Access Compliance Report Public Rights-of-Way (Curb Ramps)

Intersection ID: 50603 Main Street: RHODORA_RD Cross Street: EMPRESS_CT Location: SE

ADA ID: AA42064DB47F Ramp Type: Perp Initial Pass/Fail: Fail Overall Compliance: No Severity Score: 8.75

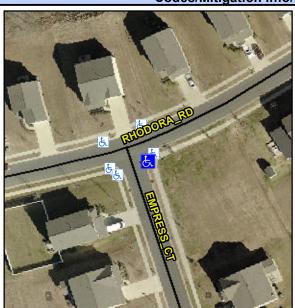
PROW/ADA:
Not Found, R304.5.1

Possible Solutions:

Remove & Replace Entire Ramp.
